ITEM FOR ENVIRONMENTAL COMMISSION AGENDA

NAME & NUMBER OF
PROJECT: McLemore Tract Multifamily Water and Wastewater Service Extension
Request #6139 and 6140

REQUEST: Water and Wastewater Service Extension Revision

DETERMINATION: Not Recommended

W. S.E.R. Name McLemore Tract Multifamily
W. S.E.R. Number: 6139
Option 1

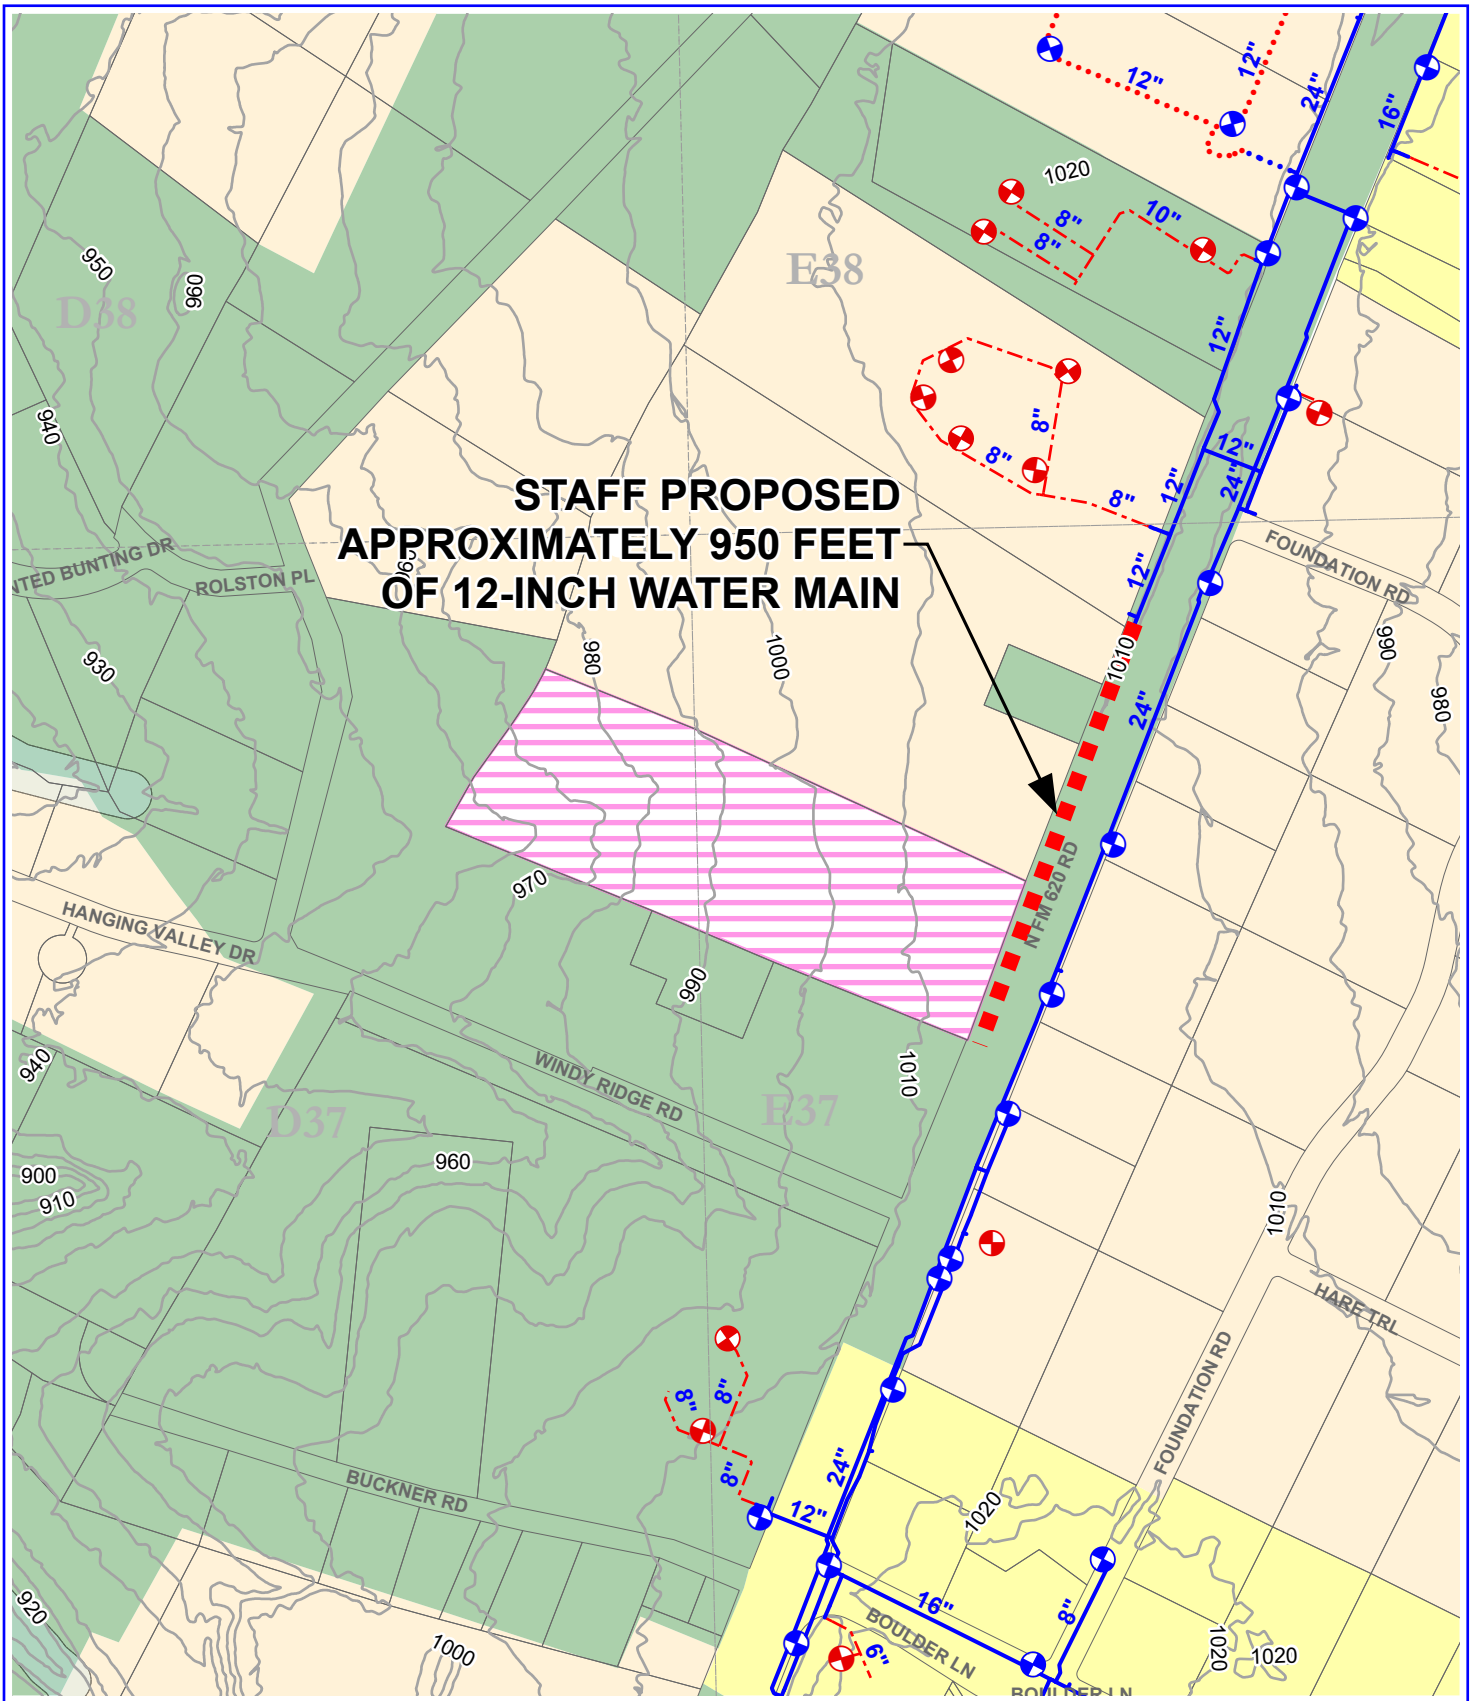
Option 1: The applicant is proposing to construct approximately 950 feet of 12-inch water main from the existing 12-inch water main located in North FM 620 south of the Foundation Road intersection and extend southwest along North FM 620 to the subject tract, as shown on the attached map.

W. S.E.R. Name McLemore Tract Multifamily
W. S.E.R. Number: 6139
Option 2

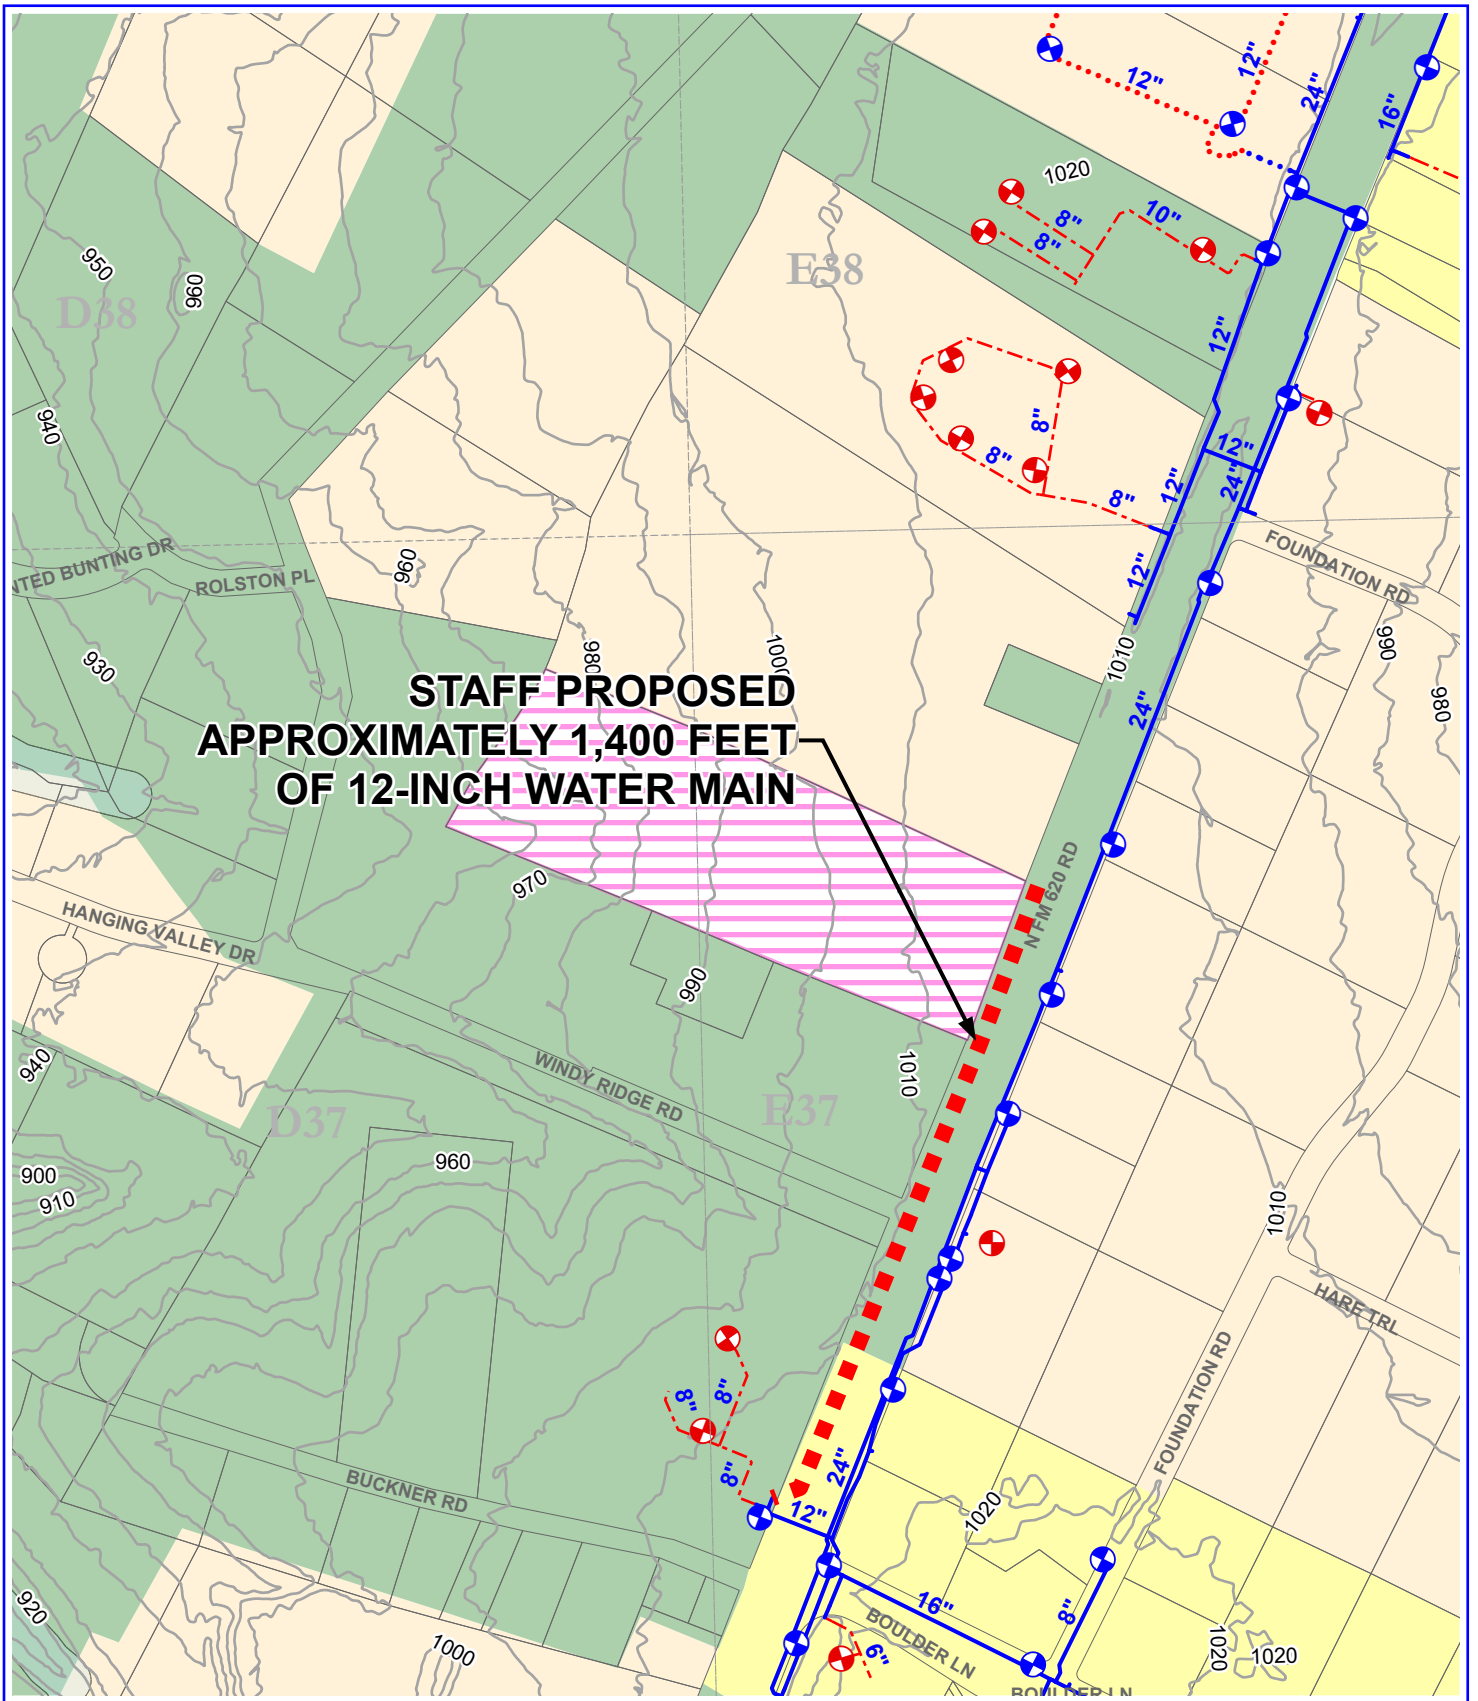
Option 2: The applicant is proposing to construct 1,400 feet of 12-inch water main from the existing 12-inch water main crossing North FM 620 north of the Boulder Lane intersection and extend northeast along North FM 620 to the subject tract, as shown on the attached map.

W.W. S.E.R. Number: 6140

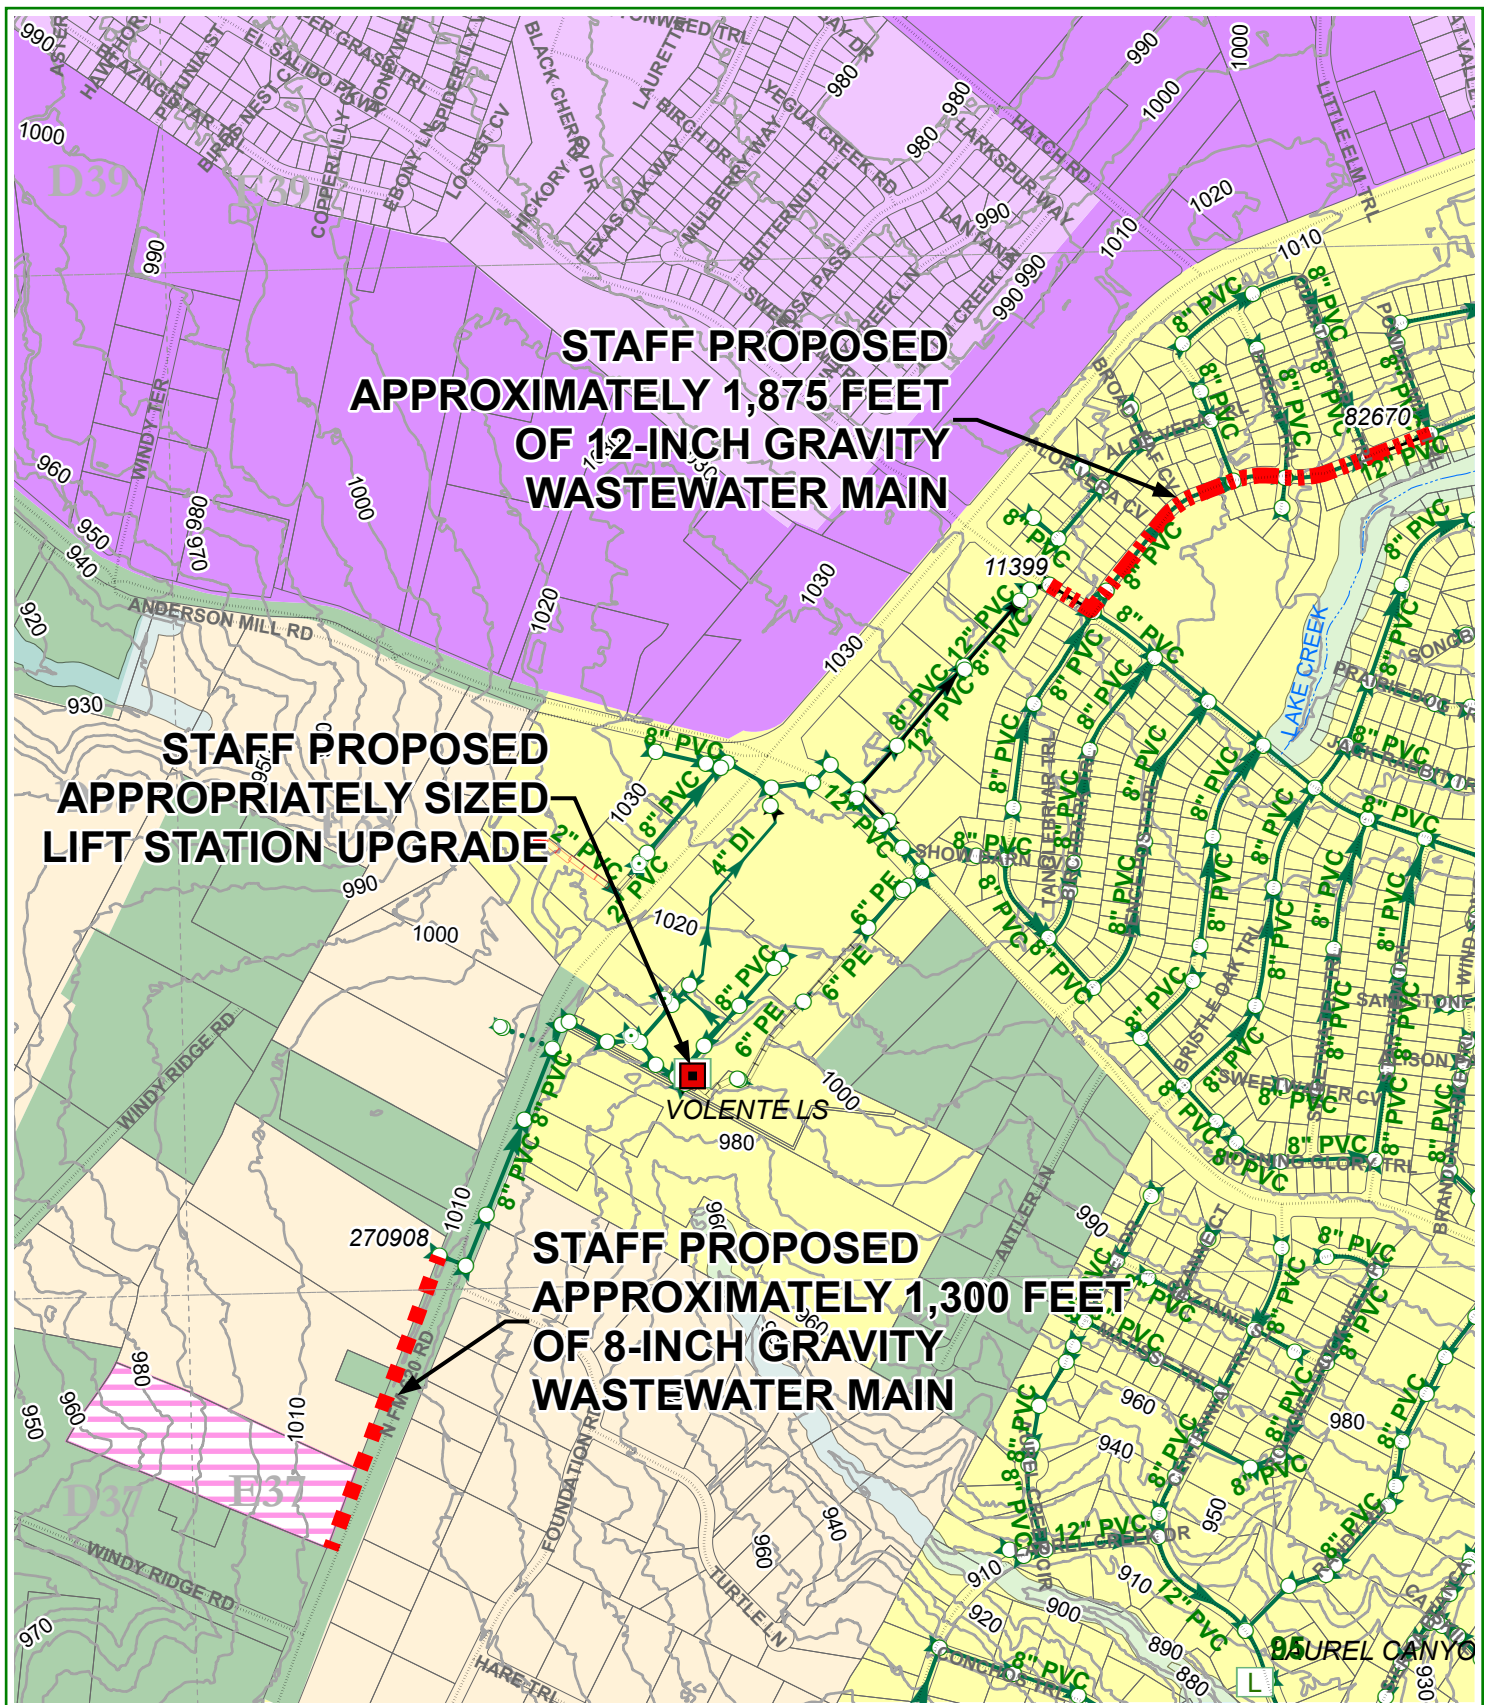
The applicant is proposing to construct 1,300 feet of 8-inch gravity wastewater main from the existing 8-inch gravity wastewater main located in N FM 620 to the subject tract, as shown on the attached map.

The applicant is also proposing to construct an appropriately sized upgrade to the existing Volente Lift station, which is also shown on the attached map.
